Re: Groundwater Assessment and Corrective Measures
Alexander County Landfill, Taylorsville, North Carolina (Permit No. 02-01)
MESCO Project No. G02003.0

On behalf of Alexander County, Municipal Engineering Services Co., P.A. (MESCO) compiled this report in response to your letter dated July 16, 2002 regarding the ongoing effort on groundwater assessment and corrective measures for the Alexander County Landfill, located in Taylorsville, North Carolina. This report serves as an addendum to the recommendations made by MESCO in its initial report submitted to the Section dated October 31, 2001 (henceforth referred to as the "original report"), and address questions and comments included in your aforementioned letter.

PLATE 1

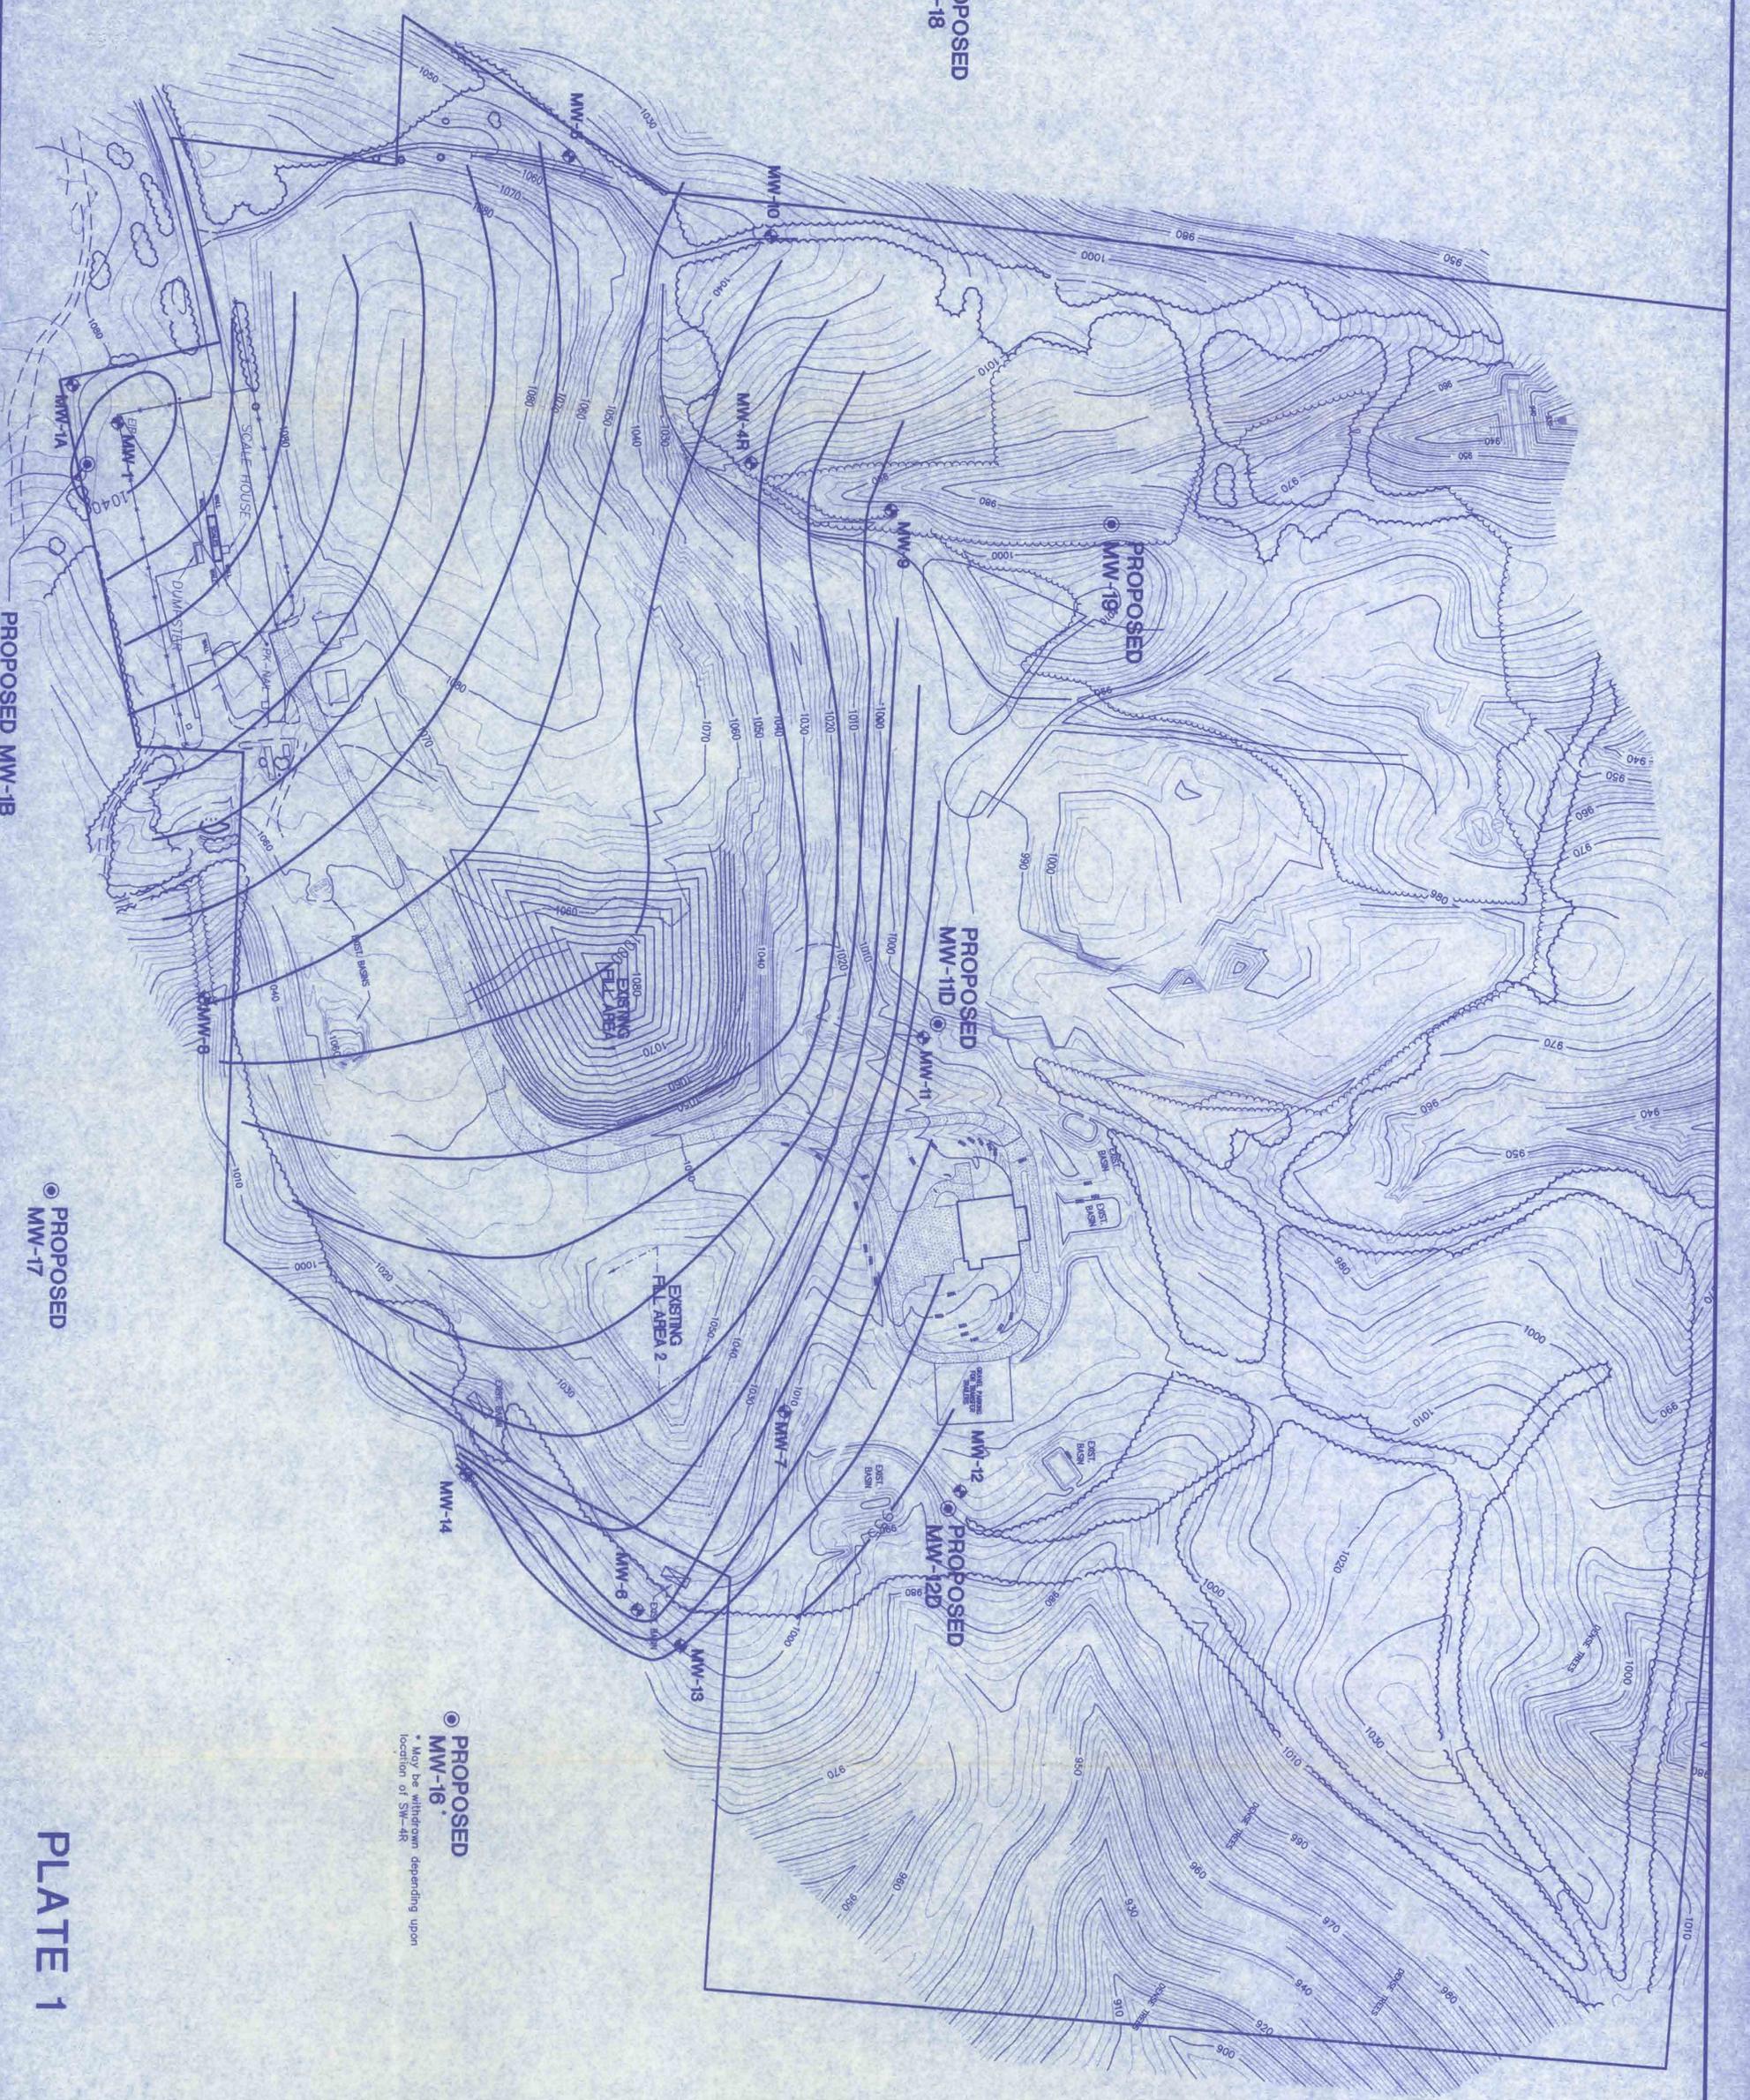
Section Comment 3: There are three groundwater-monitoring wells that may be removed from routine semi-annual sampling events. These three wells include MW-2, MW-3, and MW-15. Record the change in the sampling plan and change the symbol on the drawings to indicate that these wells are not to be sampled.

Section Comment 4: The background well MW-1A is dry. Replacement of this well is necessary, however, abandoning MW-1A is not required, and it may also be removed from service as outlined for the other wells listed above.

Section Comment 5: Two additional monitoring wells are required as part of the assessment for groundwater. Nest the new wells next to monitoring wells MW-11 and MW-12. The wells should be about 100 feet in depth, and should have a screen length no greater than ten feet. The actual well depth and screen length will be dependent on site conditions.

Section Comment 7: The north arrow on Plate 1 is not properly positioned, correct the north arrow.

MW-2, MW-3, and MW-15 will be off the monitoring network for all future sampling events. Plates 1 and 2 have been revised to remove these monitoring wells from the map.

As described in the original report, monitoring well MW-1A, due to its consistent dryness, will be replaced with a new monitoring well proposed in its immediate vicinity, and will be removed from the monitoring network. The new monitoring well will be installed at a location specified on Plate 1, and will be labeled MW-1B. MW-1A will be retained for water level measurement purposes, but will not be sampled.

Plate 1 has been modified to show MW-11D and MW-12D at their proposed locations. Their actual locations may differ depending on field conditions at time of installation.

The enclosed Plate 1 shows the correct north arrow.
